The design plans for the new home you are building for Mr Yu & Ms Chen at Lot 2190 Katandra Place, Jordan Springs are now stamped and ready for submission to Penrith City Council or your Certifier on the following conditions:

**Proposed Site Plan / Concept Drainage Plan**

PROJECT:  
**NEW TWO STOREY RESIDENCE**

DRAWING TITLE:  
**Landscape Plan**

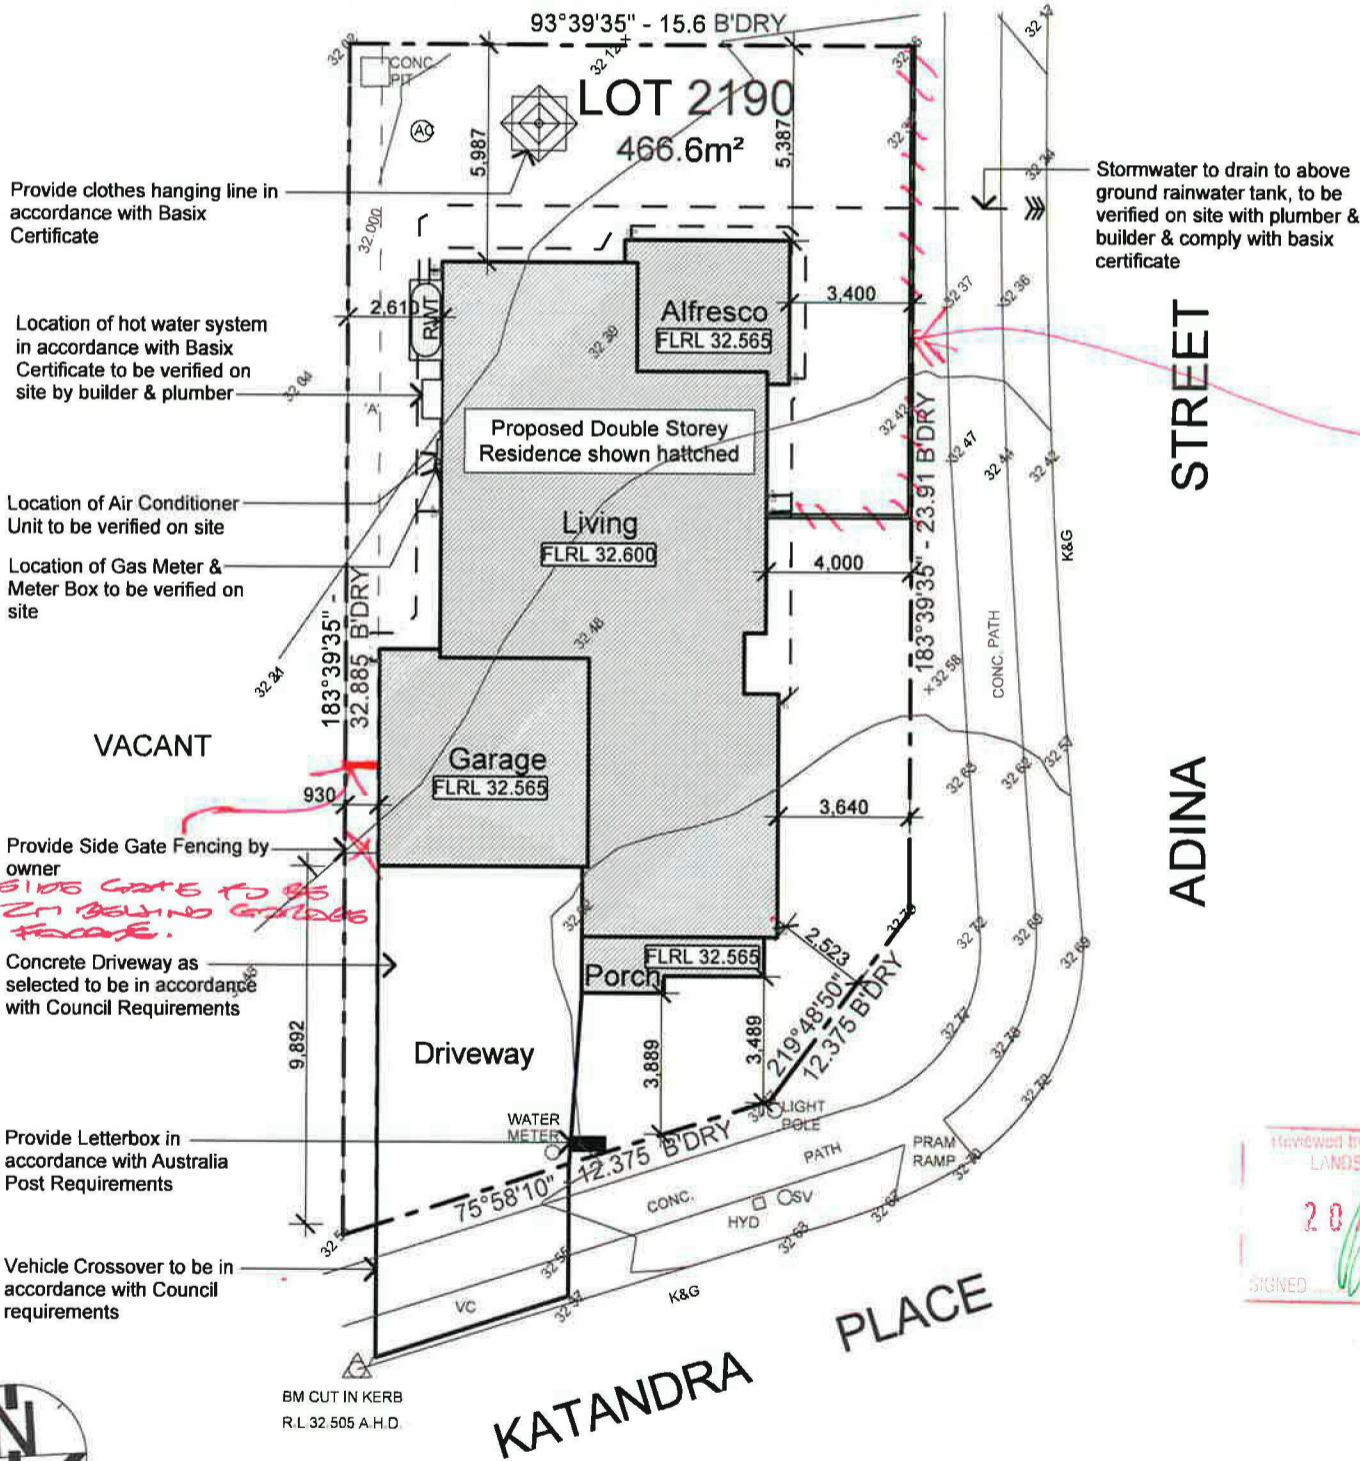
*ADD ILLOURA VILLAGE NOTES TO SITE PLAN*

*SECONDARY FENCING REQUIRED IN ACCORDANCE WITH GUIDELINES REFER DETAIL ON LANDSCAPE PLAN!*

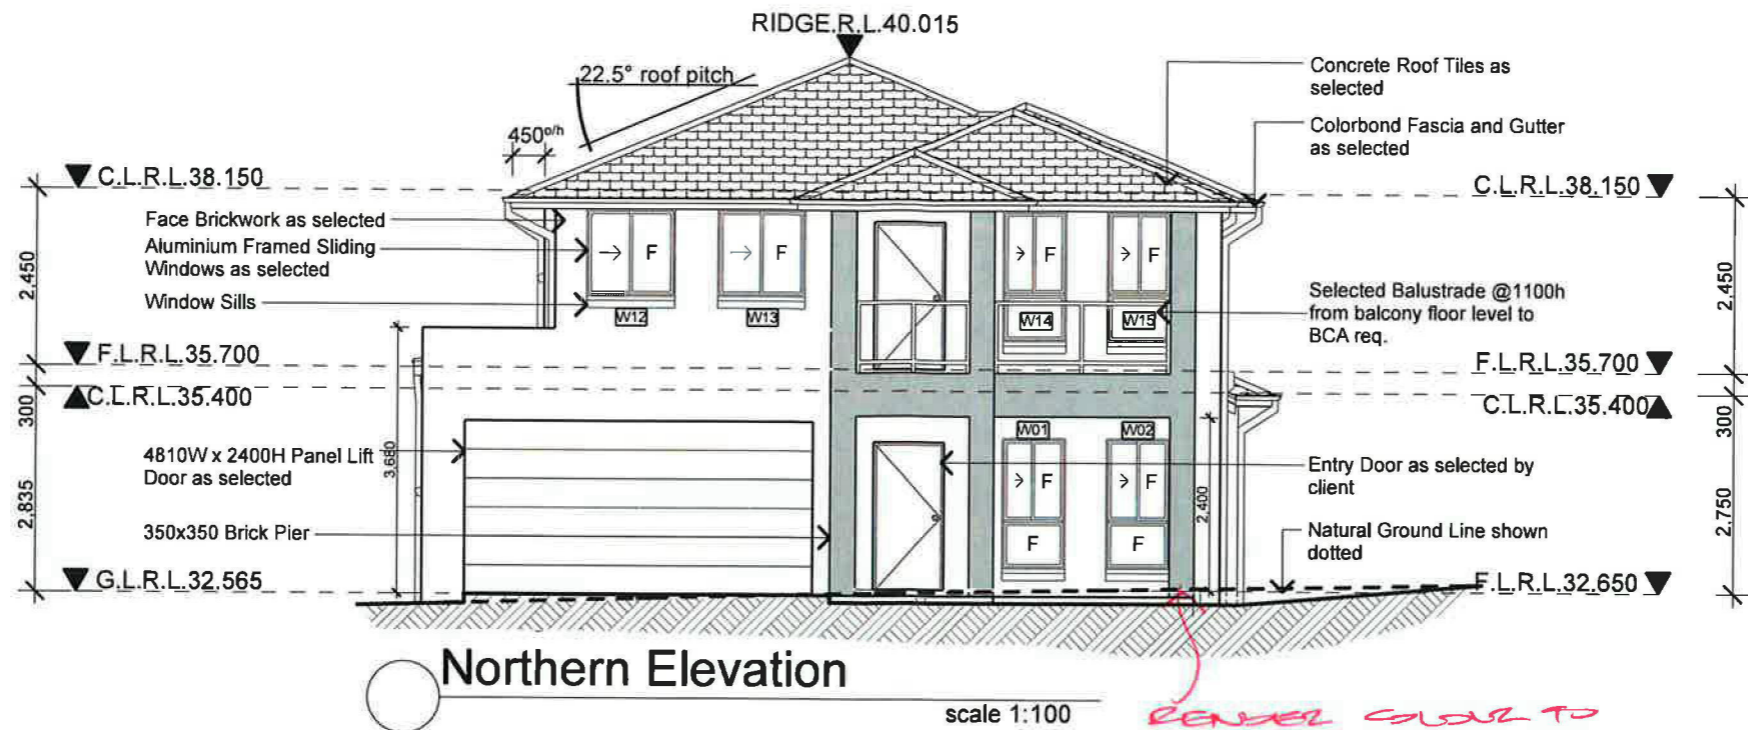
RENDER COLOUR TO BE PROVIDED ON EXTERNAL FINISHED SCHEDULE

DOORWAY MATERIAL REQUIRED TO MATCH FRAMING. SUITABLE GLASS SHOWN

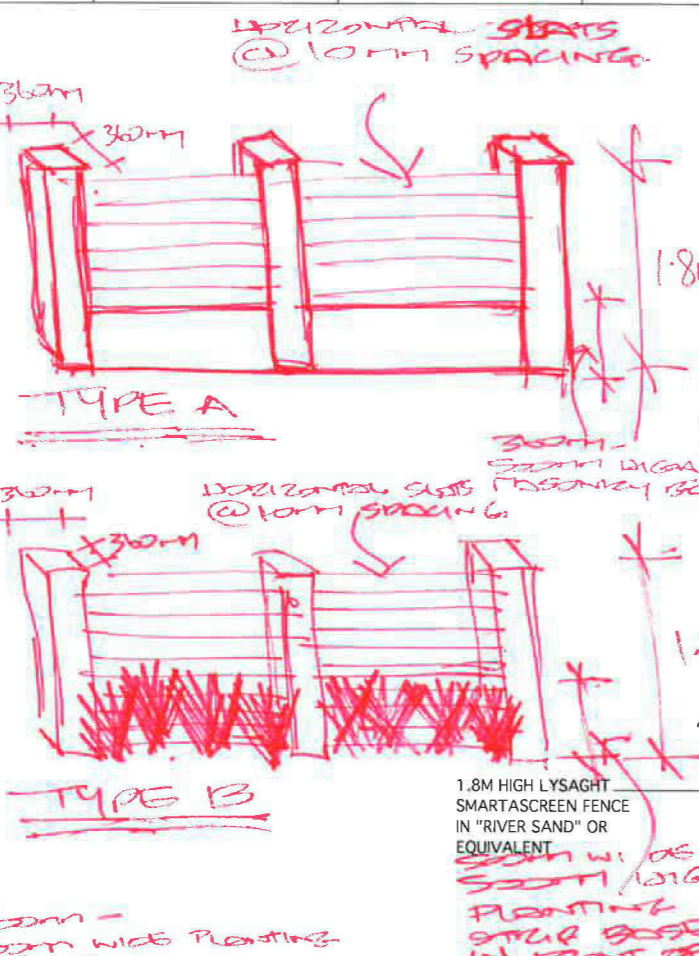
"All internal fencing and side gates/returns are to be set back a minimum of 7.5m from the front boundary or 2m behind the adjacent façade - whichever is furthest back".

Secondary plantings to be specified in accordance with Iloura Village Guidelines.

TYPE A OR TYPE B IS TO BE SPECIFIED PROVIDES DETAIL ON LANDSCAPE PLAN.

POST + RAIL MUST BE PROVIDED ON INSIDE OF FENCING NOT TO STREET
